1960 Corvette: Service Bulletin: Generator Belt Misalignment

Source: G.M. of Canada Service Bulletin

Date: April 30, 1960

GENERATOR BELT MISALIGNED DUE TO IMPROPER INSTALLATION OF GENERATOR BRACKET - 1960 Corvette Equipped With Fuel Injection

Fig. 20.

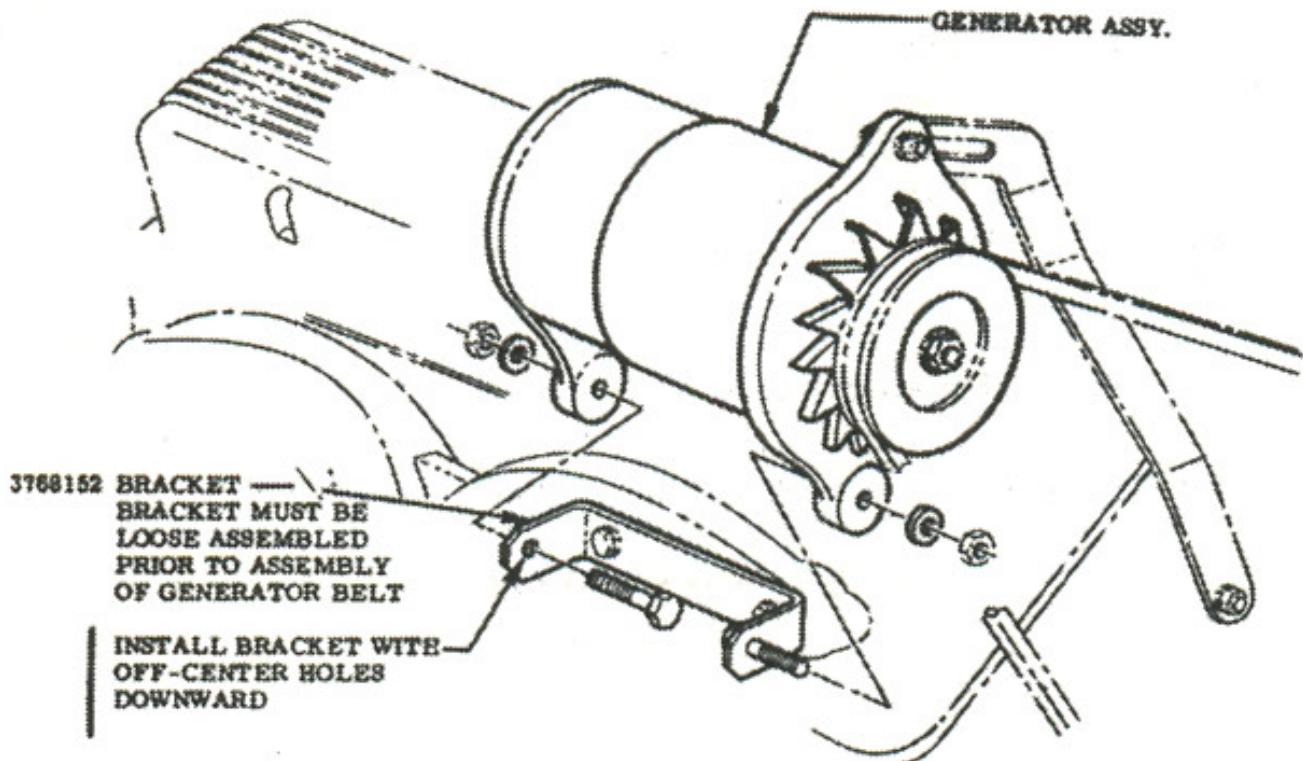
In the event difficulty is experienced with fan belt misalignment on fuel injection Corvettes only, check to see that the generator mounting bracket is assembled properly. When bracket is installed upside down, the generator is moved 1/4" too far forward. The bracket must be installed with the off-centre holes downward, as shown in Fig. 20.
